1.0 Introduction

1.1 This technical note has been prepared to discuss and provide the additional information that has been requested by West Sussex County Council (WSCC) as the Lead Local Flood Authority (LLFA) in their holding objection to DC/25/1327.

LAND EAST OF MOUSDELL CLOSE ASHINGTON

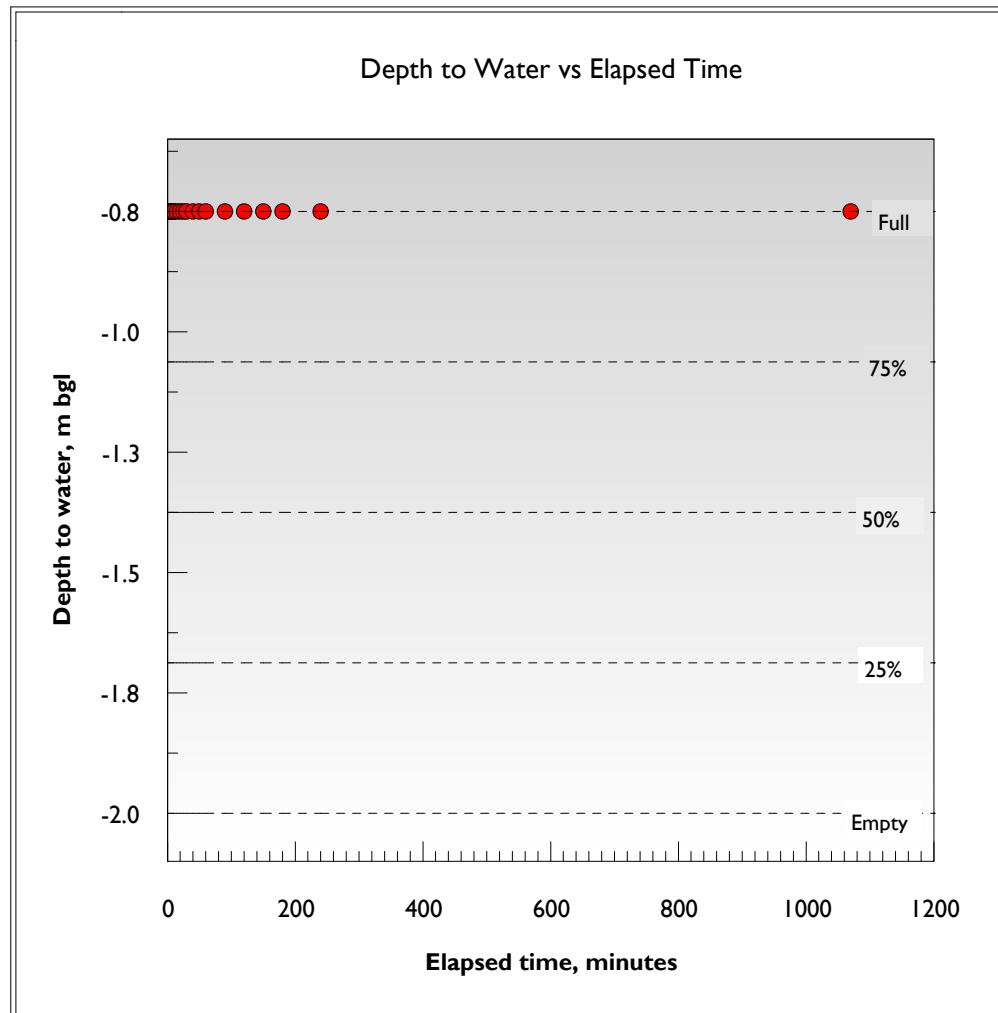
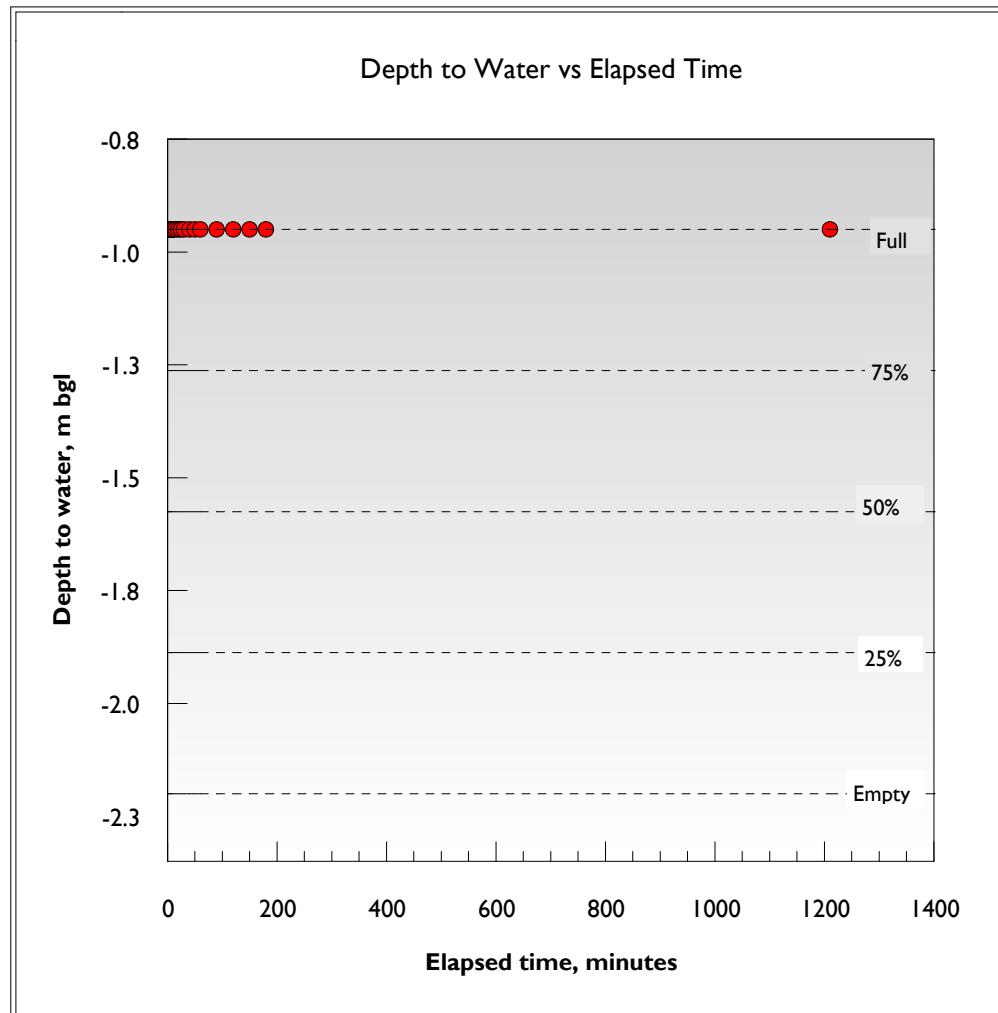
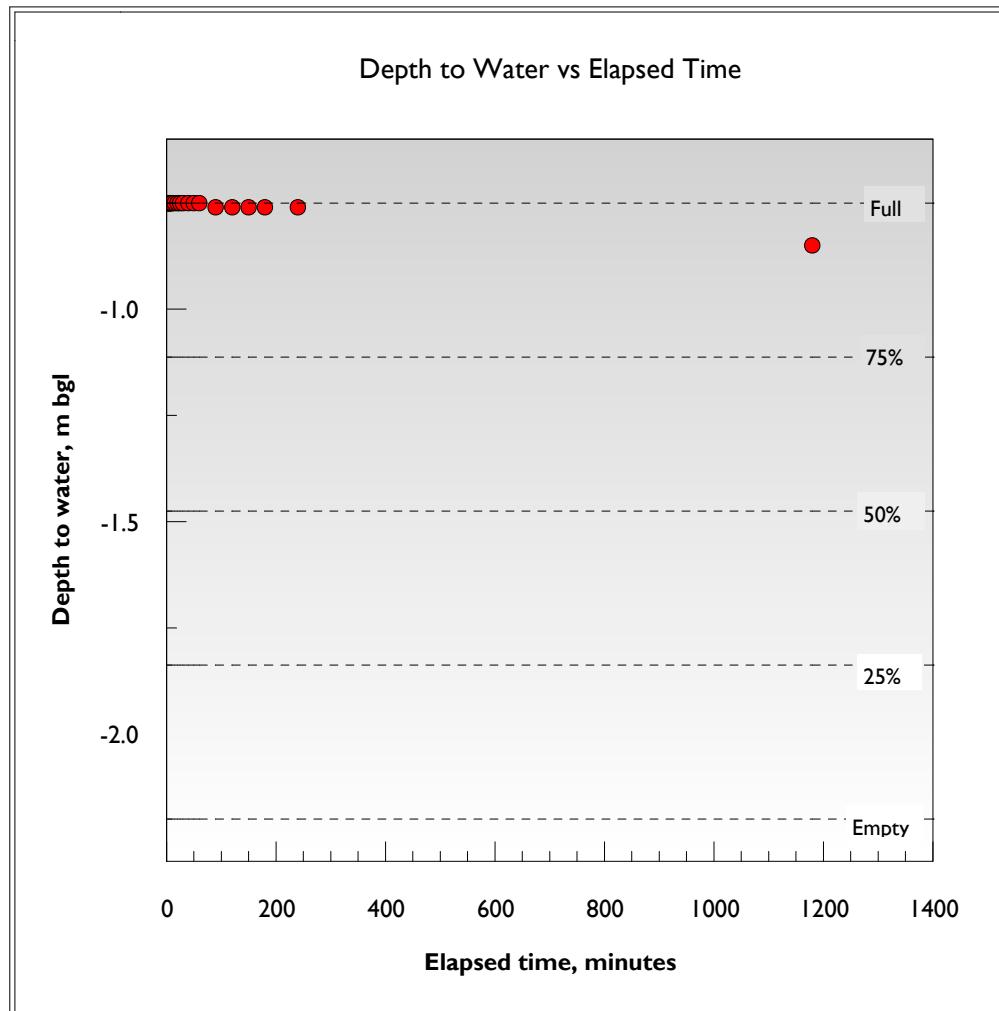
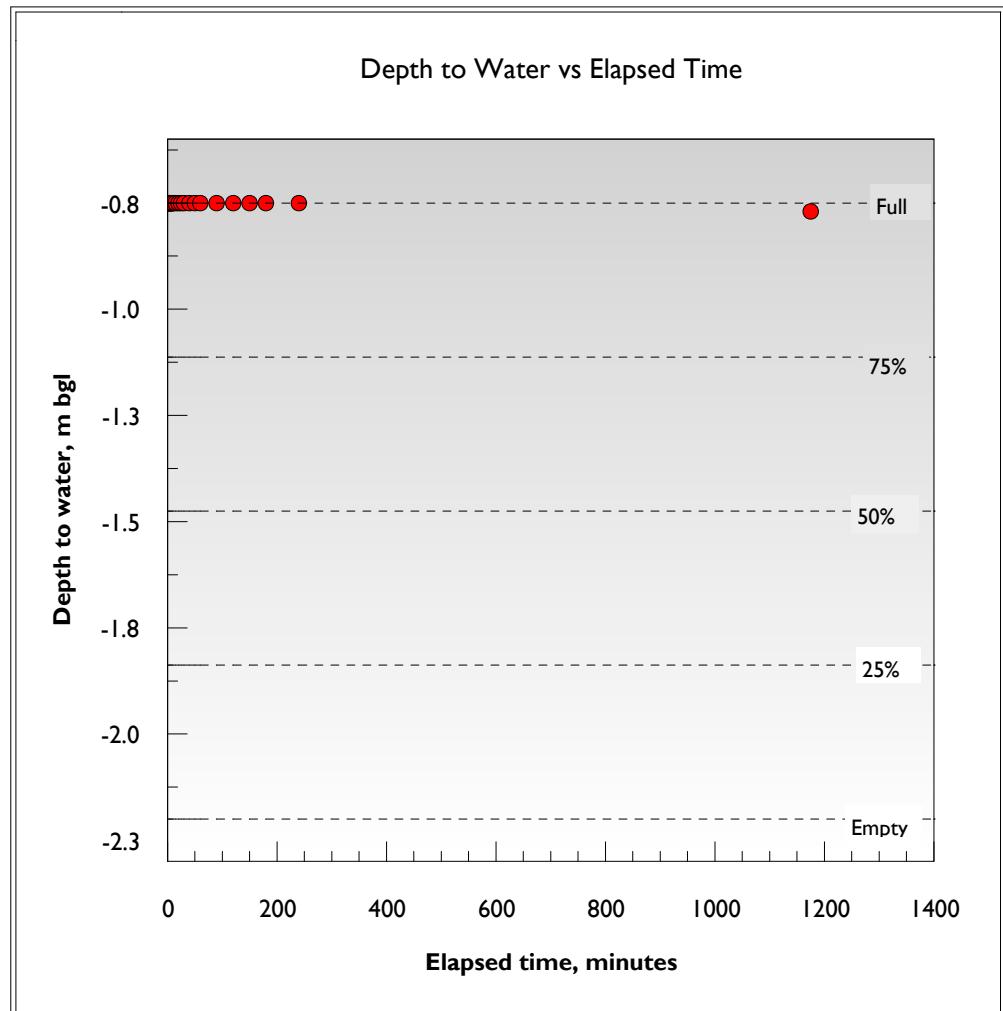
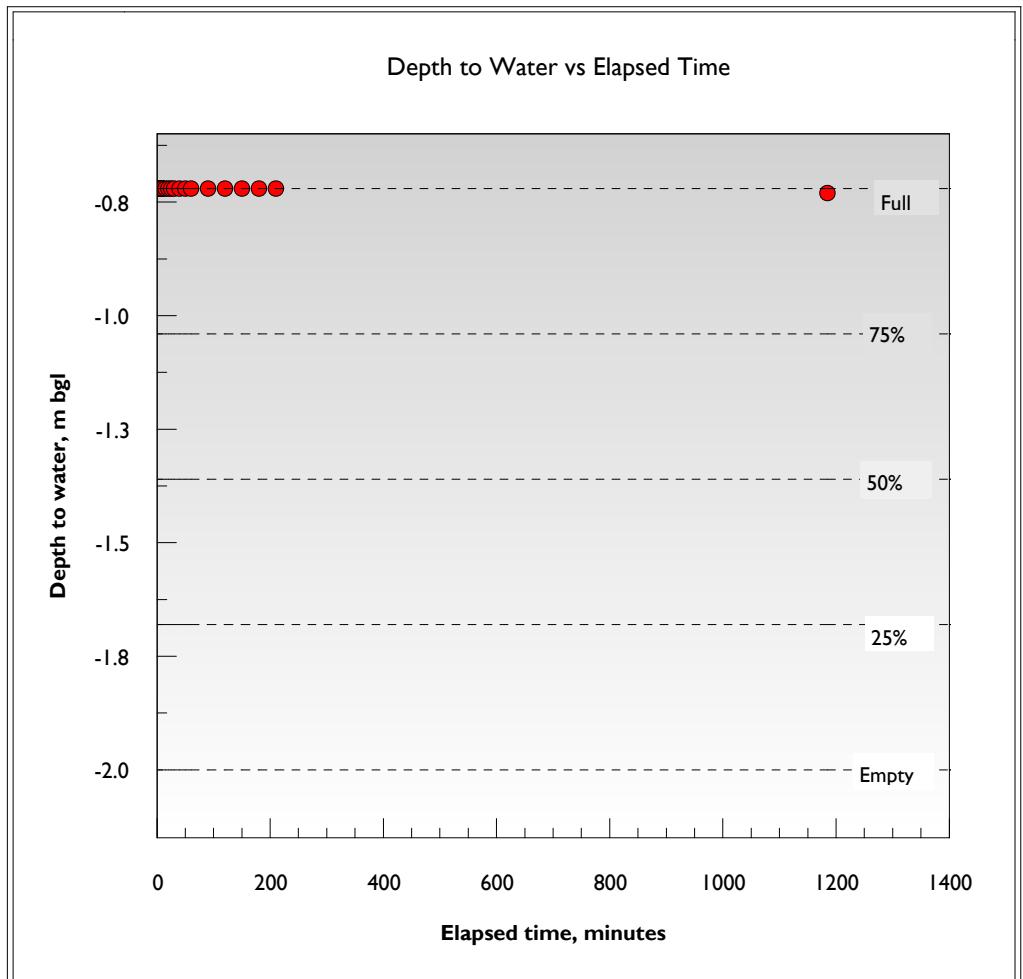
- a.) *BRE 365 percolation testing results are required to definitively determine if on-site infiltration is viable, or not. An off-site discharge of surface water is only acceptable when it has been proven that on-site infiltration is unviable.*

b.) The results of appropriate ground investigations should be submitted to support the SuDS scheme design.

2.2 We would refer the LLFA to the geoenvironmental report in [Appendix A](#) of this technical note, particularly Section 7.6 and the information within Appendix D. It confirms the assessment made in the Drainage Strategy that infiltration is not viable on the site, and this has been established through on-site BRE365 soakage testing.

Soakaway testing, generally in accordance with BRE Digest 365, was carried out at five locations with the results available at Appendix D. The infiltration rates were negligible, despite the length of time allowed for the test (overnight). Shallow, surface water soakaways are not therefore recommended at this site.

LiDAR Contour Plan Showing Watercourse Connectivity

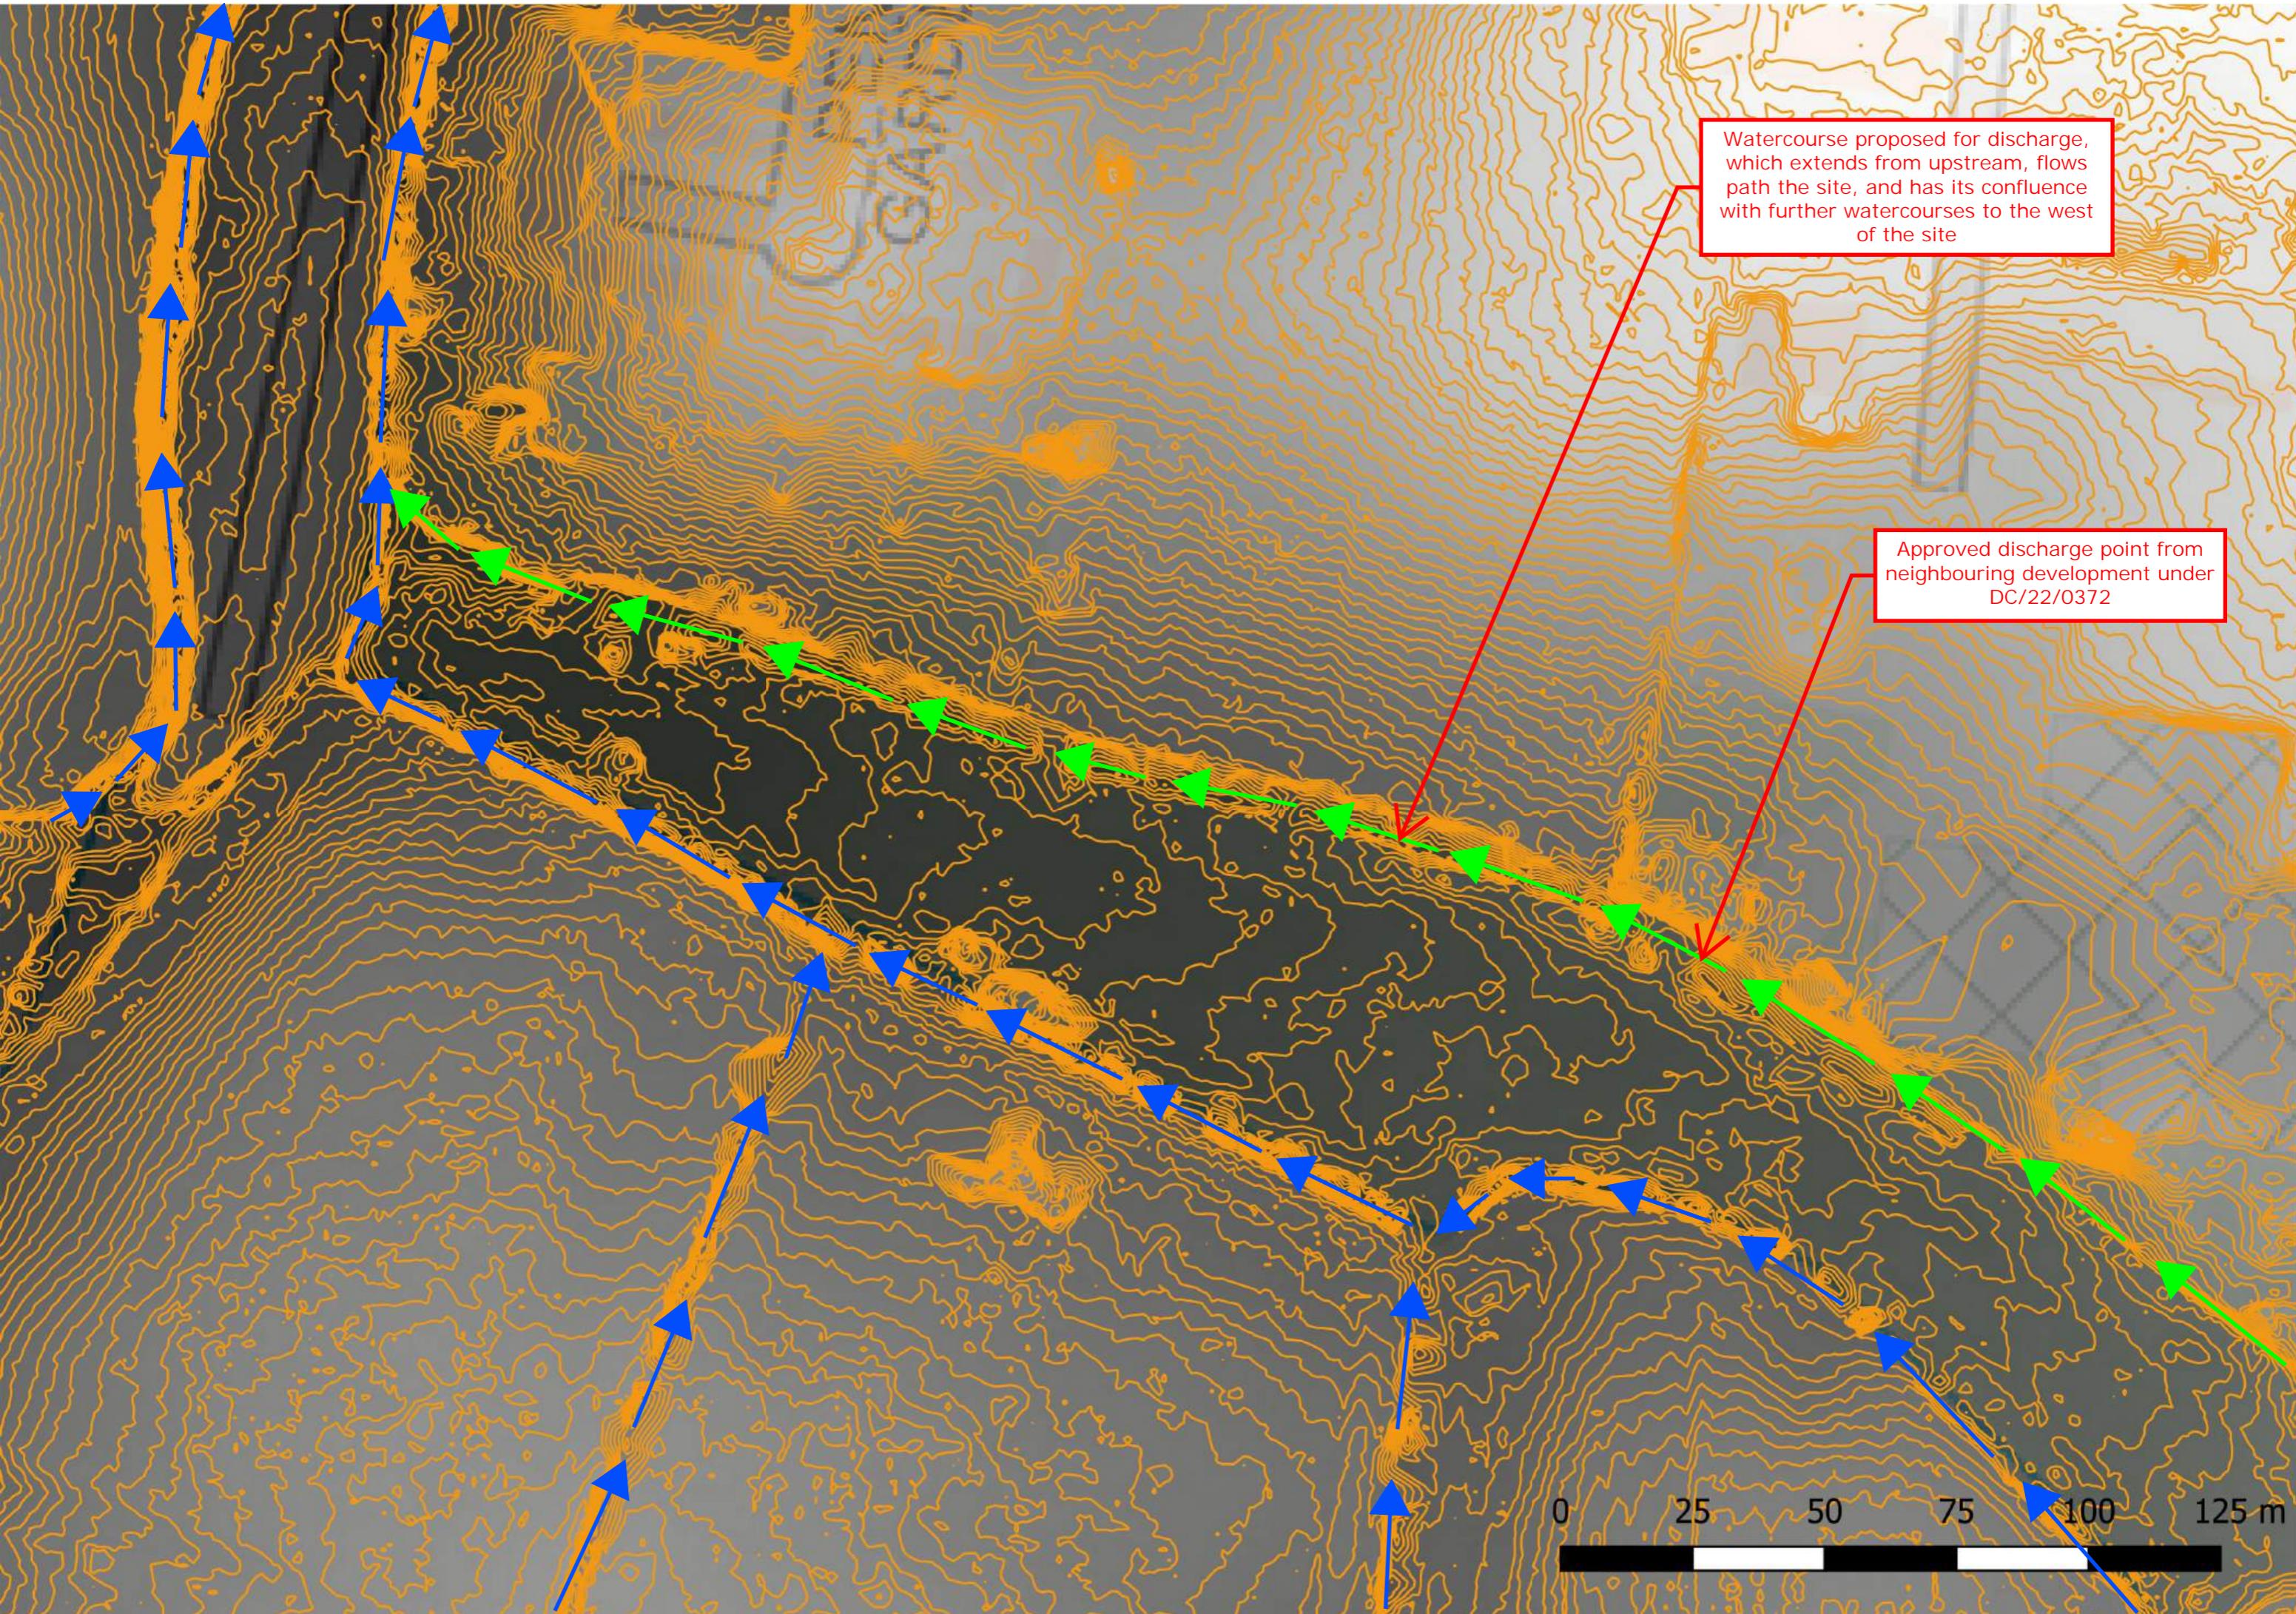
- 3.) *The surface water drainage layout submitted provides insufficient information about the receiving watercourse's: nature, condition, hard bed levels, and connectivity with the wider network of watercourses.*

- a.) *On the drainage plans the ditch stops within the red line boundary, is there connectivity with the wider watercourse network beyond the site boundary?*

c.) Further information about the acceptability of the proposed discharge to the receiving watercourse needs to be submitted.

- 2.5 With reference to planning application DC/22/0372 for the neighbouring site, the consented drainage strategy utilises a discharge to the same watercourse to which the current site intends to discharge to. The site associated with DC/22/0372 is immediately upstream of the current development, and the discharge to the watercourse was fully accepted by the LLFA. The drainage strategy proposed and accepted for DC/22/0372 is appended to this Technical Note in [Appendix B](#). Therefore, a precedent from the LLFA exists for accepting this watercourse as a suitable outfall for surface water, and from a point upstream of the current development proposals. This watercourse has ongoing connectivity and connection to the wider hydraulic network. To give the LLFA further comfort on this, we have included a LiDAR contour plan that shows the full length of the watercourse and its confluence with another watercourse to the west. This can be seen in [Appendix C](#).

- 2.6 As can be seen, due to the impervious clay-based geology, there is a well-established and connected hydraulic network.
